IN THE UNITED STATES PATENT AND TRADEMARK OFFICE

Application No.: 10/780,031 Confirmation No.: 9275
First Named Inventor: Park, Jongmin Filing Date: 17 February 2004
Group Art Unit: 2824 Examiner: Wendler, Eric J.
Atty. Docket No.: R-0003 US
Title: Technique for Programming Floating-gate Transistor Used in
Circuitry Such as Flash EPROM
Assignee(s): ProMOS Technologies Inc.

AMENDMENT TO DRAWINGS UNDER 37 CFR 1.312

Fig. 3

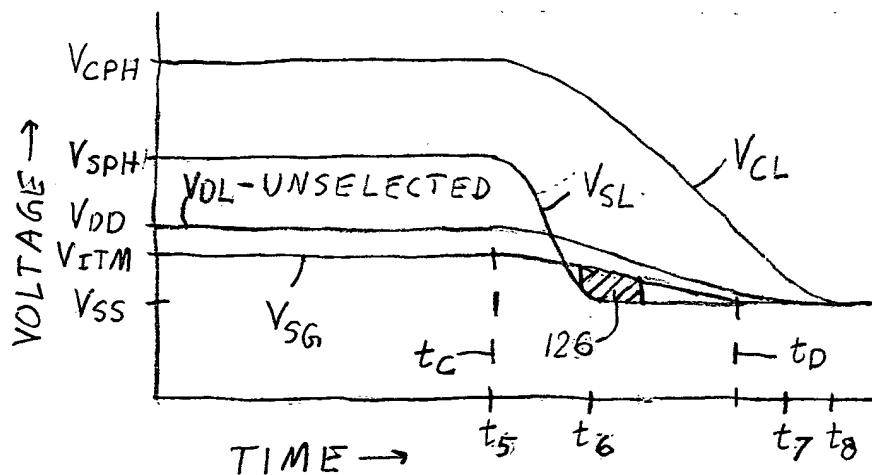
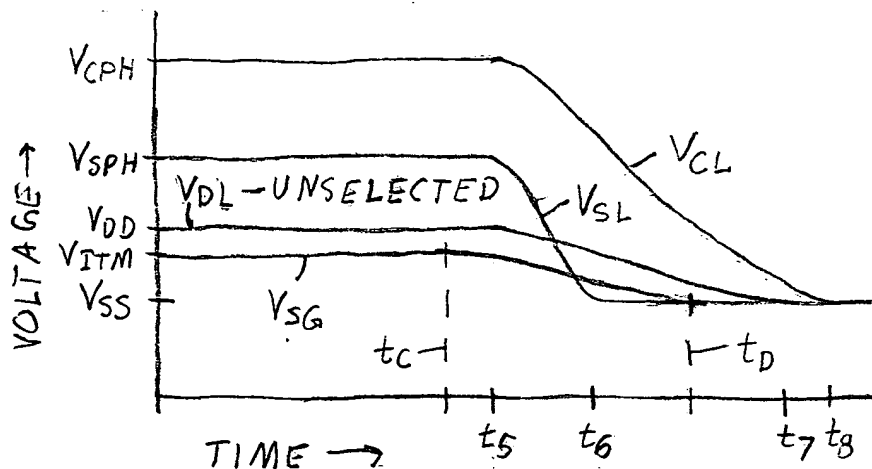
In Fig. 3, label "p" should be added to region BR.

- a. The label "p" be added to p-type region BR in Fig. 3 in conformity with how p-type region BR is labeled "p" in Fig. 15;
- b. An arrowhead be added to the lead line for reference symbol " V_{DD} " near the middle of Fig. 4 in conformity with how the lead lines for reference symbols " V_{CPH} ", " V_{SPH} ", and " V_{ITM} " in Fig. 4 all have arrowheads;
- c. A short horizontal line be added to Fig. 4 along the vertical axis next to voltage reference symbol " V_{SPH} " at the height of the label " $V_{SPH} \approx 6 \text{ V}$ " in conformity with how the other voltage levels along the vertical axis are marked with short horizontal lines; and
- d. Reference symbol "GD" be added to the thick-line diagonally shaded region directly below region FG in Fig. 15 in conformity with how the thick-line diagonally shaded region directly below region FG in Fig. 3 is labeled "GD".

Fig. 4

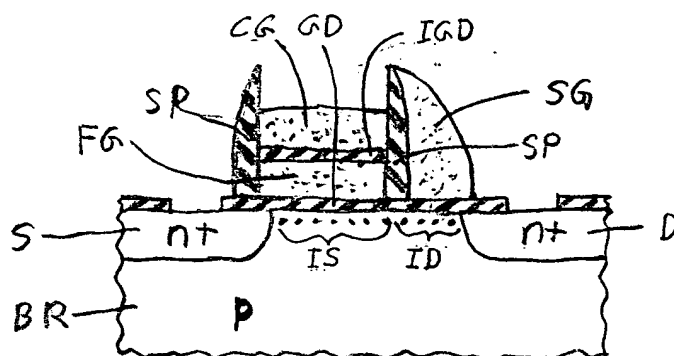
In Fig. 4, an arrowhead should be added to the lead line for reference symbol " V_{DD} " near the middle of the figure; and a short horizontal line should be added along the vertical axis next to reference symbol " V_{SPH} " at the height of the label " $V_{SPH} \approx 6 V$ ".
